Canadian Environmental  
Assessment Agency

March 18, 2016

Thank you for the comments and information submitted by Pacific NorthWest LNG Ltd. (PNW LNG) to the Canadian Environmental Assessment Agency (the Agency) on March 4, 2016. The effort undertaken by PNW LNG to review the draft Environmental Assessment Report and potential conditions for the Pacific NorthWest LNG Project (the Project) and provide detailed comments is appreciated.

**Science response to CEAA request re: updated hydrodynamics  
information and questions from external participants regarding  
inadequacies in the modeling**

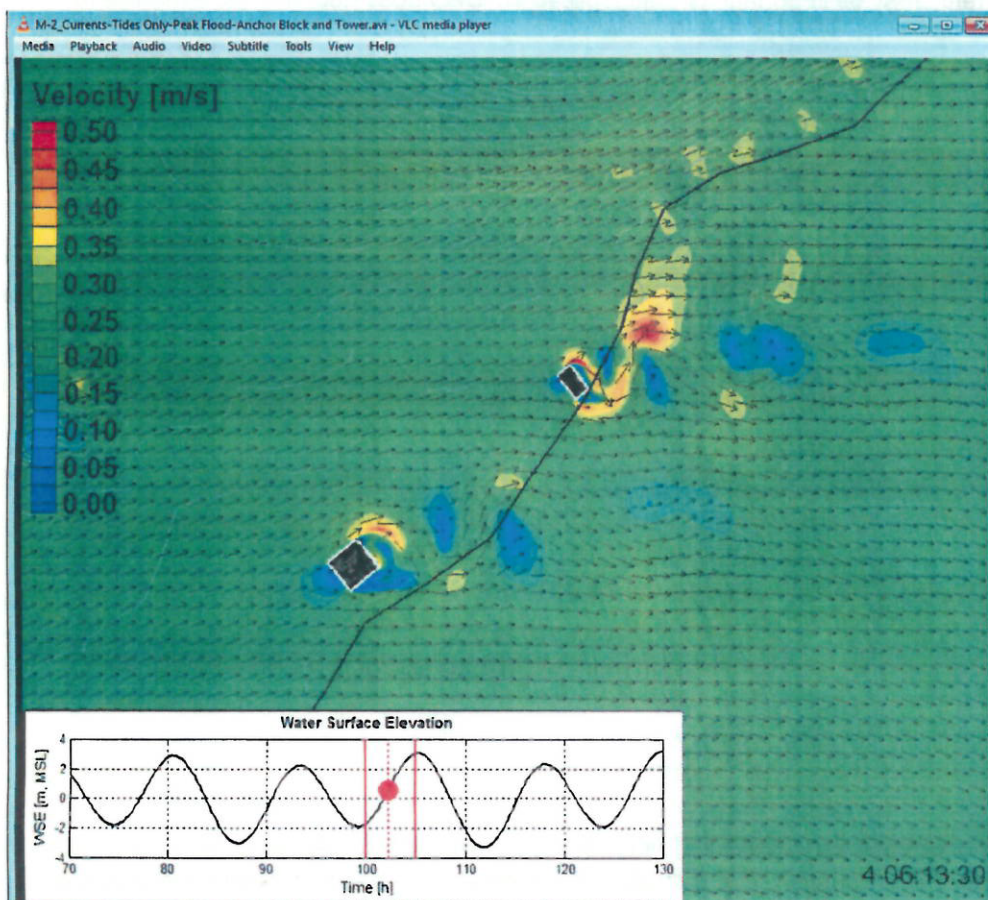
The advice that DFO provided on the potential impacts of the SW Tower and SW Anchor Block (DFO 2016), was largely based on the high resolution simulations using the MORPHO model. A snapshot of the simulated current field during flood tide with the SW Tower and SW Anchor Block in place is provided below.

The figure shows tidal currents of 20-30 cm/s (green) over much of Flora Bank. One can also see eddies being shed from the two marine structures (the blues and the yellow/red).

- The new ADCP data provide clear evidence that the currents from the Delft-3D simulations have appreciably smaller speeds than observed currents over the shallow part of Flora Bank.

- The advice that DFO provided on the potential impacts of the SW Tower and SW Anchor Block with respect to scour, total suspended solids, and changes in currents in the vicinity of the structures, does not need to be revised in light of this new information as uncertainties in the currents were taken into account in developing this advice. However, should background tidal currents speeds be shown to be 40 or 50 cm/s, then the advice would need to be revised.
